Site Instruction #8

Project: Carleton Place Arena
Neelin Street

**CIR # 39
Fire Alarm and Electrical**

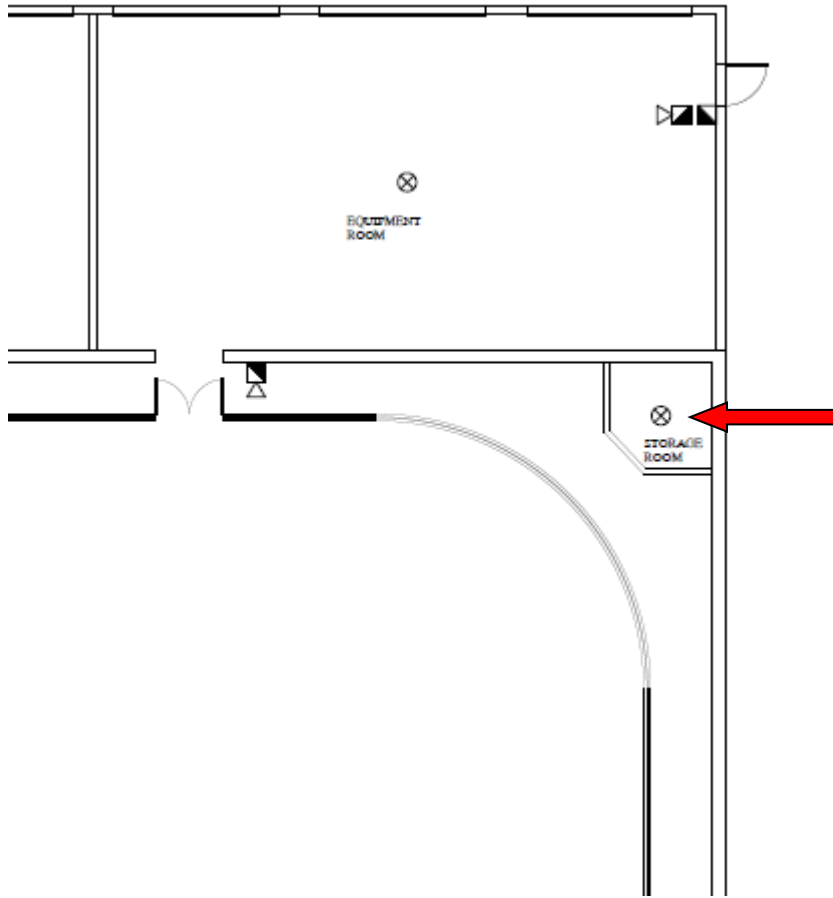
CIR #39 Question 2

- .1 The intention is to have surface mounted conduit, receptacle and device

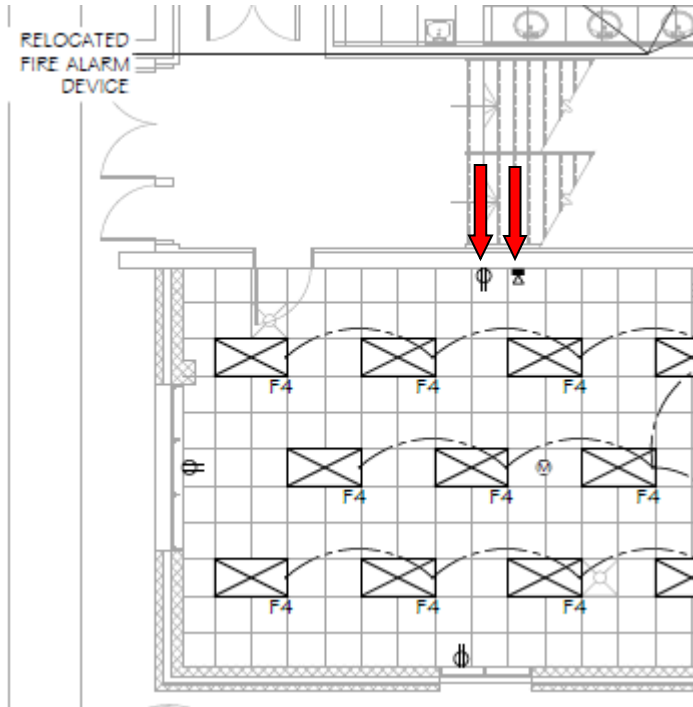
1. On FA 2 shows a heat detector in the score keeping box labelled as "Storage Area" see sketch and picture below. This is a two-story structure. Is the intent to have only one device or is there a requirement for each room to have its own dedicated heat detector device? If is not required on each room, which room are we to install the device?
Please advise.

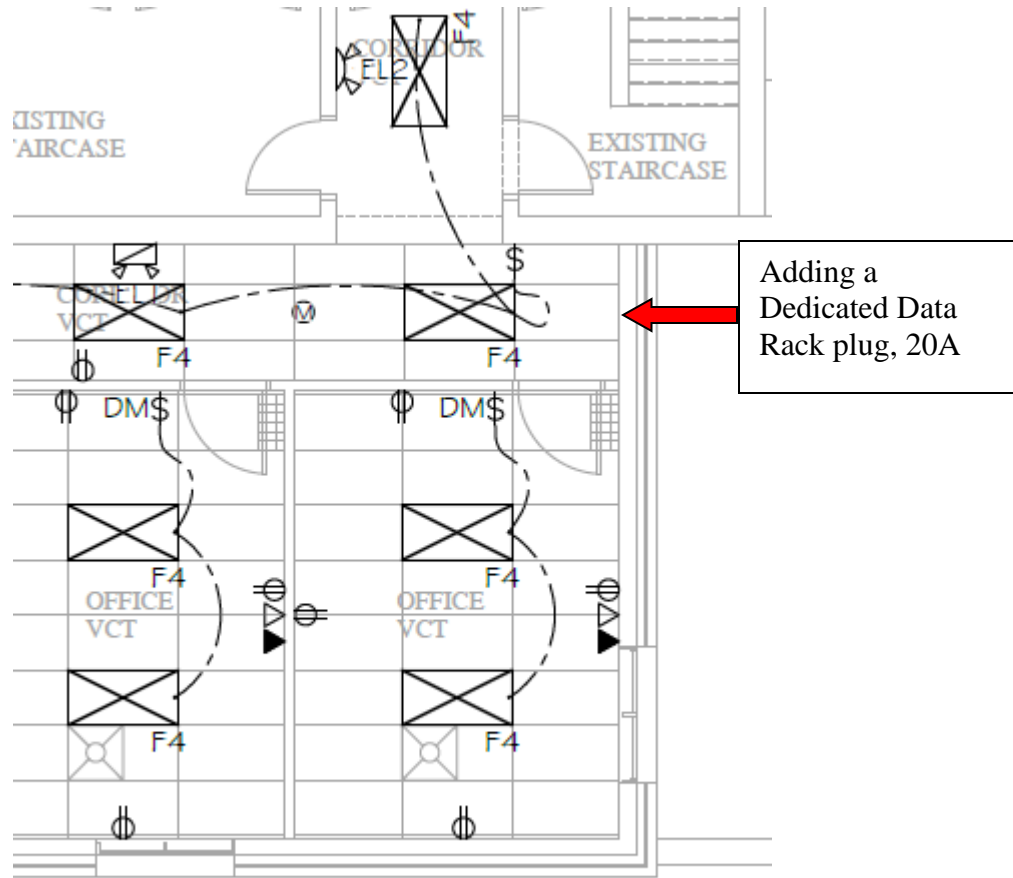
2. E-102, Electrical Receptacle and FA horn conduits and electrical box on existing wall cannot be inside the wall. See sketch below.
Is the intent to have a surface mounted electrical conduit, receptacle, and FA horn?
Please advise.
